SNDR and SNR_{TX}

(Clauses 136 and 137)

Alexander Rysin and Piers Dawe
Mellanox

Test Equipment Measurement Results

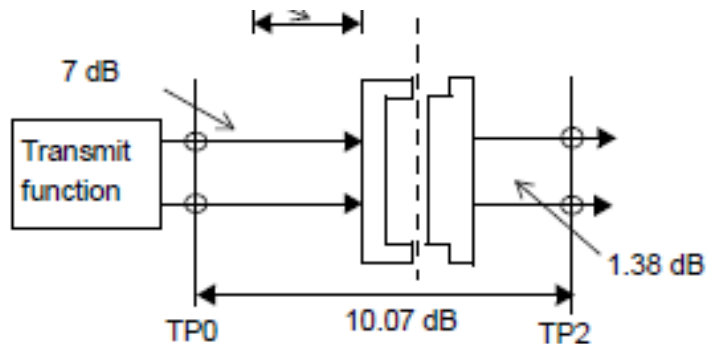
- Spec allows c(-1) range of [-0.25,0] (Preset 3) and c(1) range of [-0.25,0] (Preset 2). Is SNDR to be met for all equalization settings?
- SNDR limit very close to test equipment results, especially for equalized TX
- Results after mated compliance boards will be worse than these

CR TX Test Setup

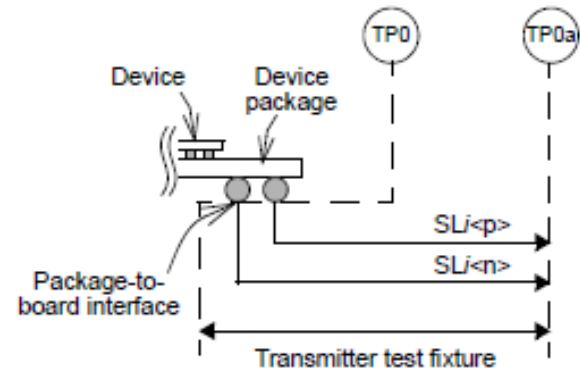
- COM SNR_{TX} is defined at the driver output (before TP0). SNDR is measured at TP2 for CR and at TP0a for KR
- Simulations show up to 4.3 dB degradation in SNDR between TP2 and TP0 and up to 3.5 dB degradation between TP0a and TP0
- Proposed mitigation: Reduce the SNDR specs in Clauses 136 and 137 to 30 dB, while keeping the COM SNR_{TX} at their respective original values
